Certificate of Appropriateness

953 N. 33RD ST. Concordia Historic District

AMENDED 10/29/19

PTS ID 114618 COA: porch and related 2019

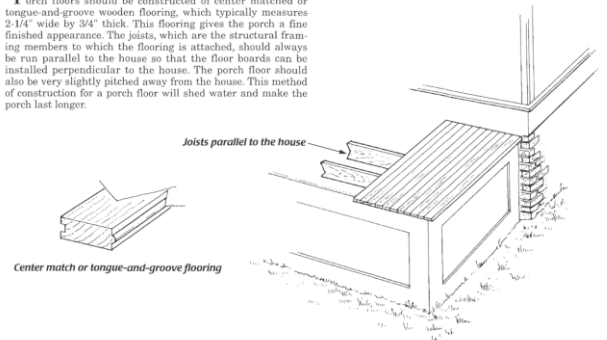
Porch roof will remain since it is integrated into the roof of the house.

All sections of the porch below the roof are to be removed including columns, balusters, steps, handrails and skirting.

New footings will be poured and the porch deck and skirting are to be rebuilt.

This photo shows work underway.

Approval for the railings, balusters, columns and handrails is addressed in this amended COA – see photos attached below.
